MOONEY AIRCRAFT CORPORATION
LOUIS SCHREINER FIELD
KERRVILLE, TX 78028

SERVICE BULLETIN M20-239A
June 13, 1989

Revision A issued to clarify Steps 2, 9 & 17 and to correct Step 10.

SUBJECT: BAGGAGE DOOR, INSIDE LATCH MODIFICATION

FIGURE M20-239-1

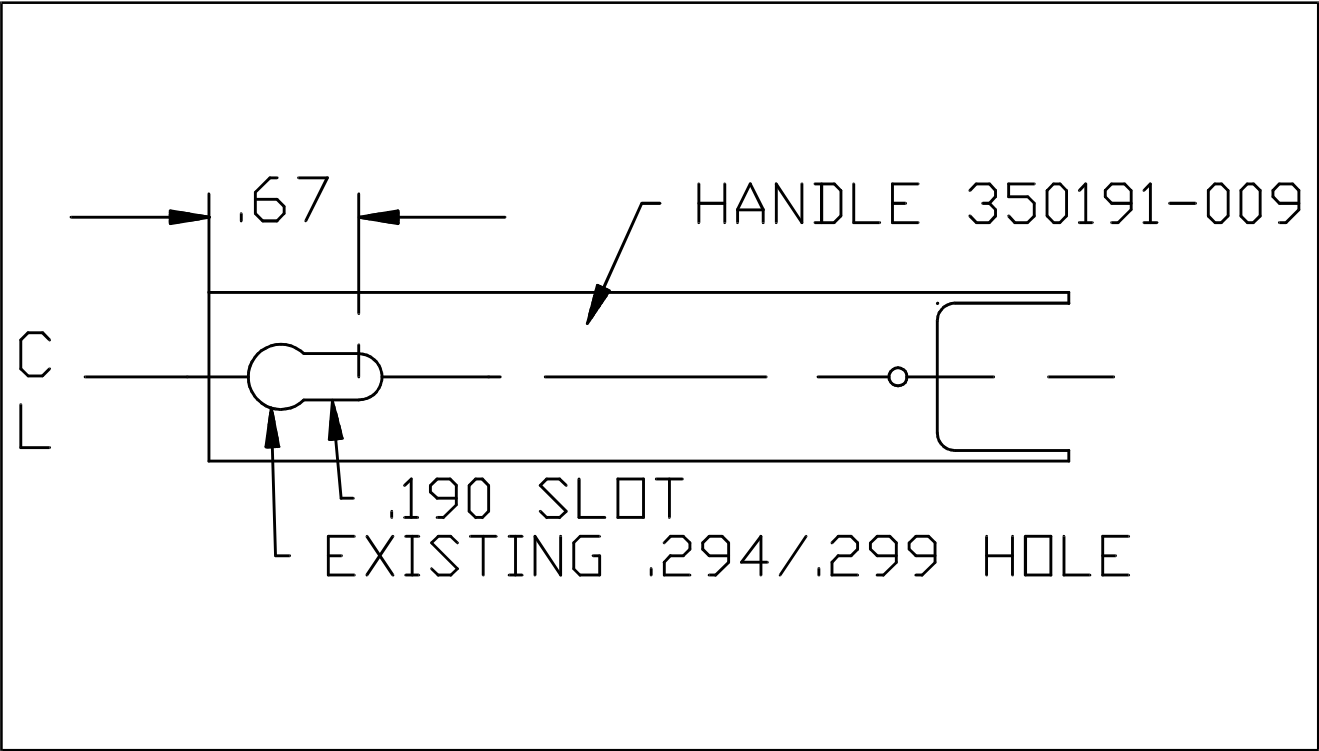
6. Remove white knob assembly from hole in red handle.
7. Modify large round hole in red handle to a slotted hole per Figure M20-239-1.
8. Remove existing clip, P/N 350191-003 or -005, from door frame by drilling out two (2) rivets.

FIGURE M20-239-2

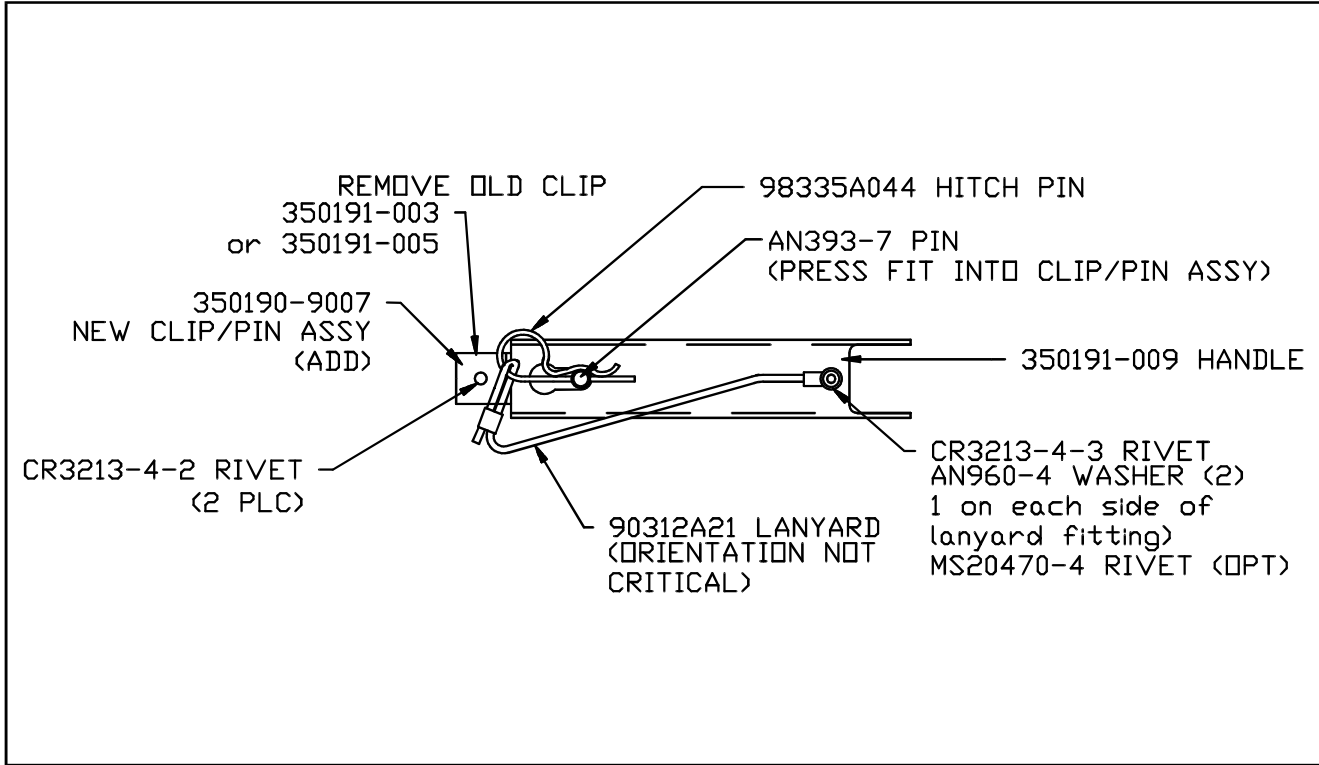
9. Install 350191-9007 clip/pin assembly, with small hole toward red handle pivot point; locating pin relative to slot in handle as illustrated in Figure M20-239-2. Existing holes should line up; if not, drill two (# 30 drill) holes into baggage door using pilot holes in clip/pin assy as a guide. Install with two CR3213-4-2 rivets.

10. Install lanyard, P/N 90312A21, on red handle per Figure M20-239-2. Use CR3213-4-3 rivet and two AN960-4 washers (one under rivet head and one on back side of red handle).
